Serial No. 10/820,288
Docket No. VAP023PA (Formerly VSTI-12U)

Amendments to the Drawings:

FIG. 1

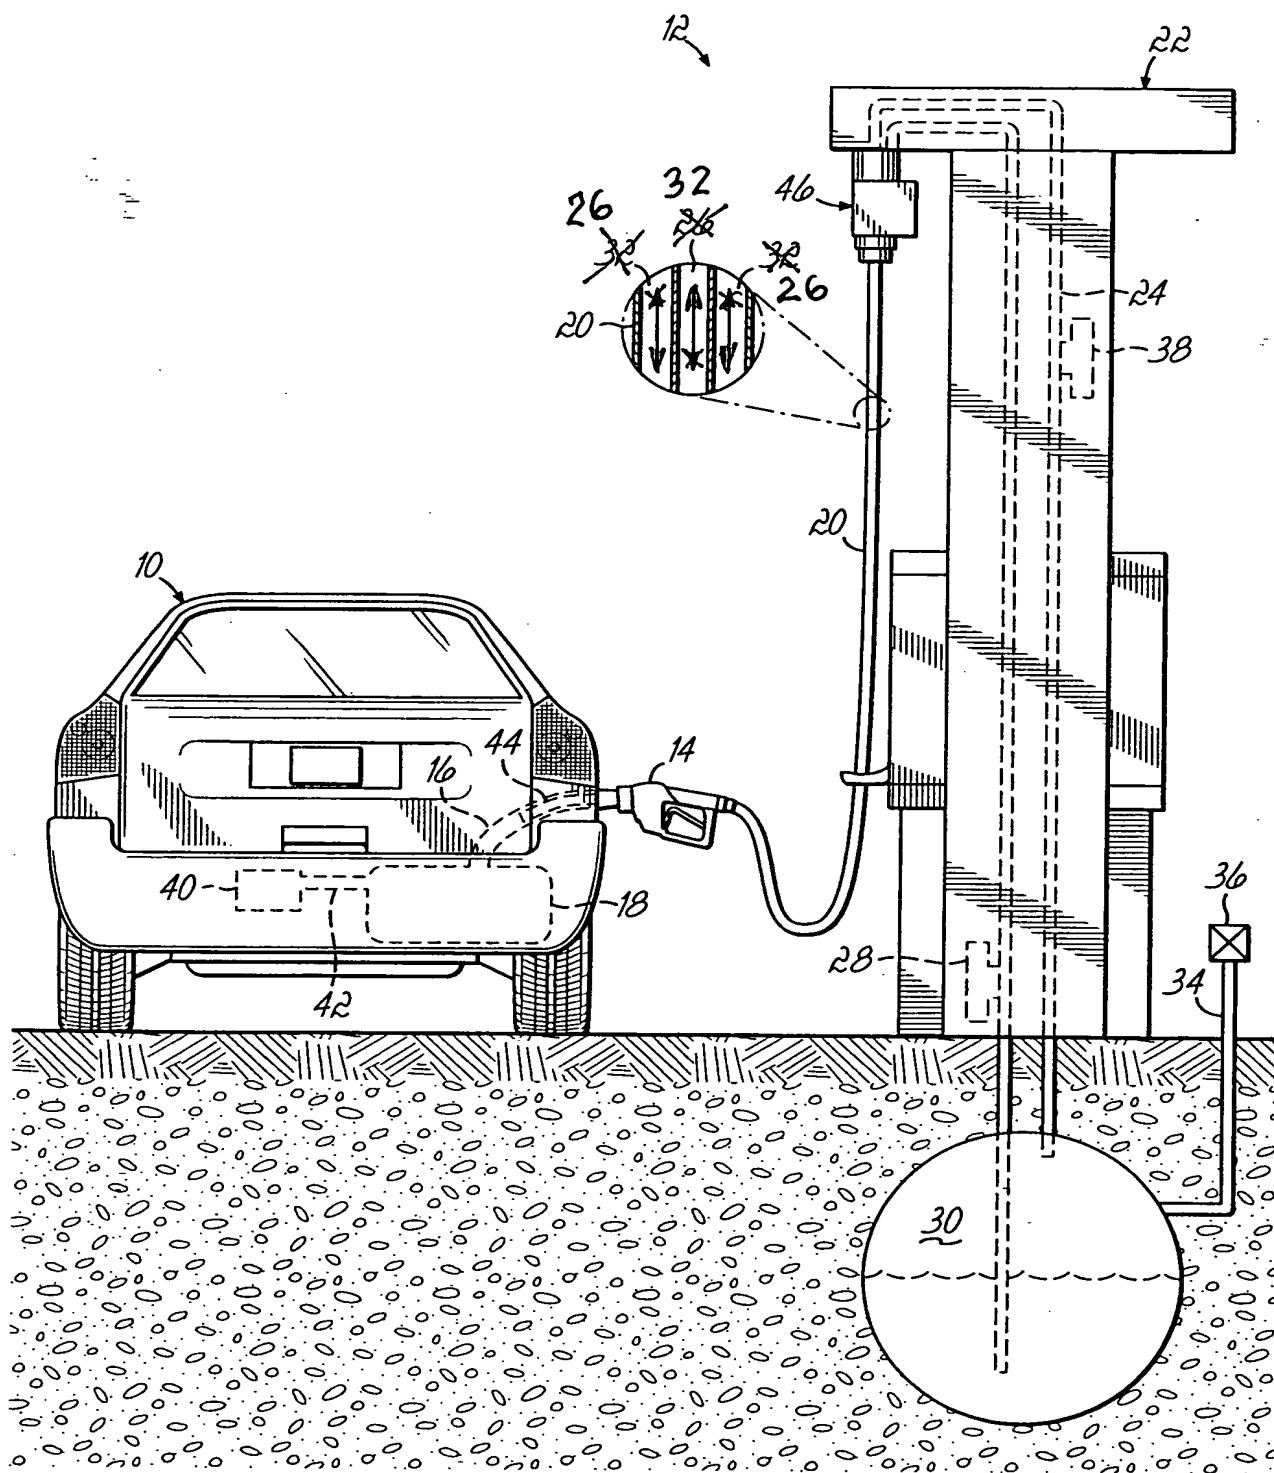
Eight (8) new sheets of formal drawings are enclosed to replace the nine (9) sheets of formal drawings mailed to the Office on April 20, 2004, with Figs. 2A and 2B of previously submitted sheet three (3) being deleted from the present application. For the convenience of the Examiner, also enclosed are copies of previously submitted drawing sheets 1 and 2 having the changes marked in red ink. (Enclosure C). In Fig. 1, the cut-away view of the interior of the fuel delivery hose 20 has been changed to correspond to Fig. 2 and the specification as originally filed to show that the hose 20 has an annular fuel delivery passageway 26 and a central, tubular vapor passage 32. In Fig. 2, the arrow for reference numeral 100 has been redirected to point to the fuel shut-off mechanism; the head of the venturi poppet member 124 has been correctly identified by the reference numeral 126; the extraneous reference numeral 124 over the tandem vapor/fuel control valves has been deleted; and, the reference identifiers associated with the fuel discharge end of the nozzle have been deleted to correspond to the cancellation of Figs. 2A and 2B from the present application.
